**Revised NOTICE OF A PUBLIC HEARING BEFORE
THE CITY COUNCIL ON AN APPEAL OF THE
PORTLAND HISTORIC LANDMARKS COMMISSION**

CASE FILE: LU 17-153413 HRM AD (The Portland Building)
WHEN: AUGUST 24, 2017, 3 pm
WHERE: COUNCIL CHAMBERS, 1221 SW FOURTH AVENUE

Date: August 16, 2017
To: Interested Person
From: Hillary Adam, Land Use Services, 503-823-3581

PROPOSED ELEVATION MATERIALS NORTH

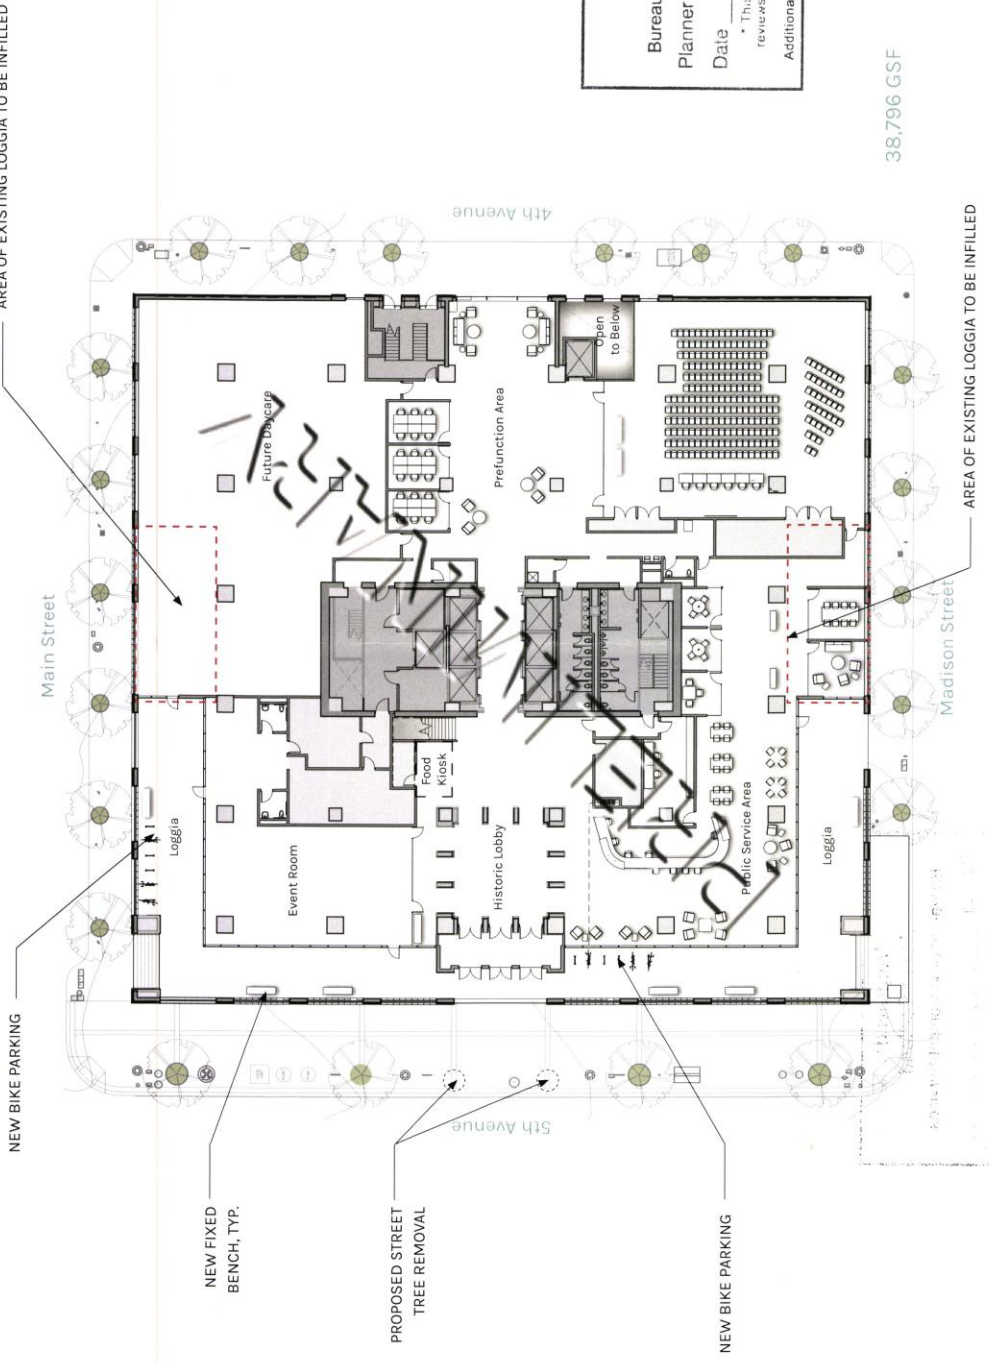
- F. The historic teal tiles at the main 5th Avenue entry shall remain as shown in Exhibit C-74-revised.
- G. The proposed air handling units shall either be located at the interior of the building, or be significantly (at least 50%) reduced in scale (and not increased in number).

NEW MECHANICAL UNIT PAINTED ROSE-BEIGE TO MATCH PENTHOUSE *see Cond. 9

"G. The proposed air handling units shall either be located at the interior of the building, or be significantly (at least 50%) reduced in scale (and not increased in number)"

The applicant is appealing condition 'G' and asks that it be removed from the approval decision.

As described to the Landmarks Commission in our June 26th hearing, there is no viable technical solution that meets the condition stated without creating significant negative impacts to the project. The project team has done extensive studies regarding type and location of mechanical equipment that will deliver optimum performance and air quality while minimizing visual impact. The design shown in the proposal reflects this.

Locating the air handling equipment in the interior of the building per the condition is not feasible. These units need to draw fresh air into the building and the best source for high quality outside air is at the roof level. Drawing air from lower elevations would result in reduced air quality for the building occupants and would require large louvers to be placed somewhere within the historic facade. The addition of these louvers would disrupt the historic design and potentially reduce valuable existing window area. Drawing air from the roof to air handlers located in the basement would require significant structural changes in order to accommodate new vertical shafts, would significantly reduce the usable square footage in the building, and would result in a significant drop in the efficiency and life span of the air handling equipment. This scenario would also add significant cost to the project.

Reducing the size of the equipment by 50% is also not technically feasible. The Portland Building is a 15 story building that is intended to house over 1,700 employees. Reducing the equipment size would result in insufficient air distribution for the building occupants and would not meet code.
